Access Compliance Report

Public Rights-of-Way

(Curb Ramps)

Intersection ID: 10315	Main Street: E_34TH_ST	Cross Street: N_ALEXANDER_ST	Location: E
ADA ID: D8A7390E4F19	Ramp Type: Perp	Initial Pass/Fail: Fail	Overall Compliance: No
		Severity Score: 10

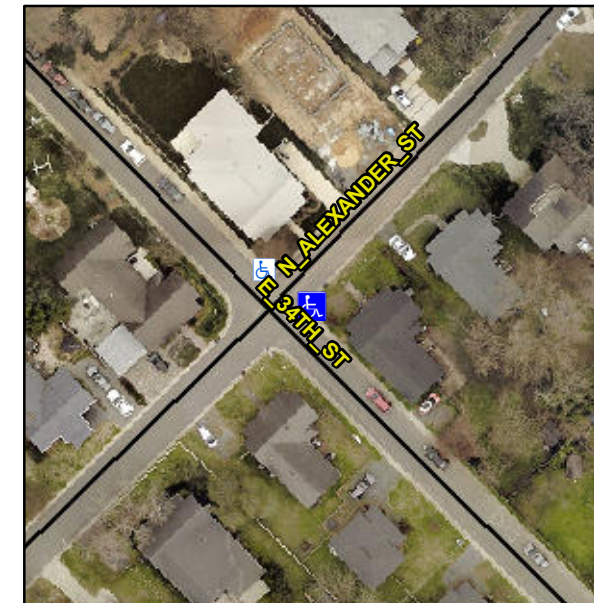
Not Found, R304.5.1

Compliance	Description	Data	Compliance	Description	Data
N/A	Ramp Length (in)	57.0	Yes	Ramp Slope (%)	6.4
No	Ramp Width (in)	41.0	Yes	Ramp XSlope (%)	3.0
N/A	Flare Type LT	N/A	N/A	Flare Type RT	N/A
N/A	Flare Slope LT (%)	N/A	N/A	Flare Slope RT (%)	N/A
N/A	Flare Traversable LT?	N/A	N/A	Flare Traversable RT?	N/A
N/A	Landing Length (in)	N/A	N/A	DWS Provided?	N/A
N/A	Landing Width (in)	N/A	N/A	DWS Contrast?	N/A
N/A	Landing Slope (%)	N/A	N/A	DWS Length (in)	N/A
N/A	Landing X Slope (%)	N/A	N/A	DWS Full Width?	N/A
N/A	Landing Curb? (Y/N)	N/A	N/A	DWS Offset (in)	N/A
N/A	Shared Landing?	N/A			
N/A	Gutter Ponding?	N/A	N/A	Gutter Slope (%)	N/A
N/A	Gutter Lip Ht (in)	1.0	N/A	Gutter X Slope (%)	N/A
N/A	Painted X Walk1?	No	N/A	Painted X Walk2?	N/A
	X Walk 1 Direction	To NW		X Walk 2 Direction	N/A
N/A	X Walk 1 Width (in)	N/A	N/A	X Walk 2 Width (in)	N/A
	X Walk 1 Slope (%)	0.3		X Walk 2 Slope (%)	N/A
	X Walk 1 X Slope (%)	3.1		X Walk 2 X Slope (%)	N/A

Remove & Replace Entire Ramp.
